# UNITED STATES PATENT AND TRADEMARK OFFICE

| APPLICATION NO. | FILING DATE | FIRST NAMED INVENTOR | ATTORNEY DOCKET NO. | CONFIRMATION NO. |
|-----------------|-------------|----------------------|---------------------|------------------|
| 10/614,650      | 07/07/2003  | Yong Hua Zhu         | LOMAU.122C1         | 7638             |

| <b>Office Action Summary</b> | <b>Application No.</b><br>10/614,650 | <b>Applicant(s)</b><br>ZHU ET AL. |  |

## **DETAILED ACTION**

**Examiner-annotated Fig. 30 of Zhu**

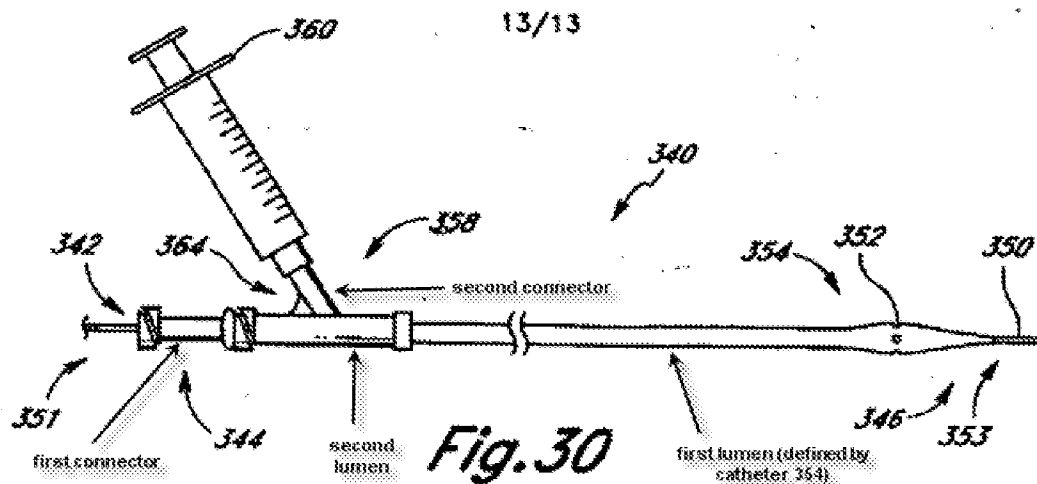
With respect to **claim 21**: Zhu discloses a device for at least partially closing an opening in

tissue, comprising: an elongate body in the form of dual lumen catheter 340 comprising a first lumen defined by catheter 354 having a first distal opening and a second lumen 358 having a second distal opening, a first connector adapted to provide access to the first lumen 340 (Fig. 30); a second connector adapted to provide access to the second lumen 358, e.g. for attachment of syringe 360(Fig. 30); and a wound cover member in the form of a wound closure device releasably connected to the elongate body 340 at the first distal opening via its position on the guidewire 350 releasably attached to said elongate body 340; and wherein the wound cover member and the elongate body are configured so that when the wound cover member is released from the first distal opening of the elongate body at or adjacent an opening in tissue, the wound cover member is wholly disconnected from the device. (Page 18, line 15-Page 19, line 19) As can be seen in annotated Fig. 30 of Zhu below, the lumens are arranged so that a longitudinal space is defined between the first and second distal openings; wherein the device is configured so that, during advancement towards an opening in tissue and during operation the first distal opening is permanently maintained at a position distal of the second distal opening, and the first and second lumens do not communicate with one another.

With respect to **claim 10**: The elongate body 340 has a first portion comprising the first lumen and a second portion comprising the second lumen 358, and the first and second portions are rigidly connected to one another so as to always move as a single elongate unit.

With respect to **claim 34**: The device disclosed by Zhu additionally comprises a release rod, guidewire 350, wherein the first lumen is adapted to slidably receive the release rod 350 therein. (Fig. 30, Page 18, lines 34,35)

With respect to **claim 41**: The second connector defines a second connector lumen and, as can be seen in the annotated version of Fig. 30 *supra*, an axis of the second connector lumen is

disposed in a direction generally transverse to an axis of the second lumen. (Fig. 30)
